Service Note		
Products	Description:	Service note no.
VoiceLive Play and VoiceLive Play GTX	Fuse F1 blown	SNo-T0162

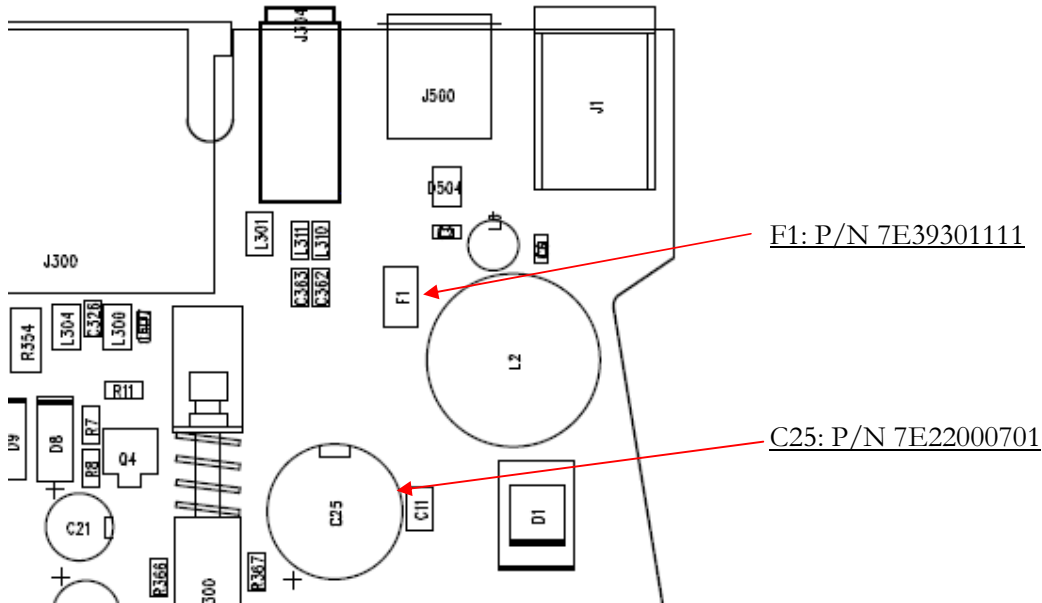
We have encountered a problem on a few VoiceLive Play and VoiceLive Play GTX products. The error has been reported as a blown fuse (F1) when a Power supply unit with other specifications than the matching TC Helicon supply has been used.

F1 has to be replaced (TC stock no: 7E39301111, 1A Slo-Blo Fuse 63V-AC/DC 1206). The problem is only seen on the very first production batch, where C25 is a 1000 μ F. This one must furthermore be changed to a 100 μ F (TC stock no: 7E22000701, 100 μ F 20% 63v ELEC.CAP. PCAPR200-400)
